# Product Change Notification

**Change Notification #:** 114620 - 00

**Date of Publication:** May 19, 2016

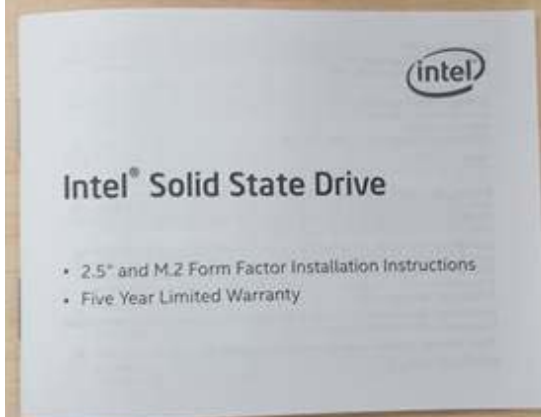
The following Intel® SSD Series firmware versions are being updated. The changes in the new firmware versions are incremental improvements from previous versions. Inventory will transition in the Intel factory on or beyond the above date to replace older firmware versions with the latest version.

The Firmware is being updated as follows:

Product Name	Impacted Firmware Versions	Mitigated Firmware Versions
Intel® SSD 540s Series 2.5"	LSBG200	LSF031C
Intel® SSD 540s Series M.2	LSBG100	LSF031C
Intel® SSD E 5400s Series 2.5"	LSMG200	LSF031E
Intel® SSD E 5400s Series M.2	LSMG100	LSF031E
Intel® SSD DC S3100 Series 2.5"	LSDG200	LSF031D
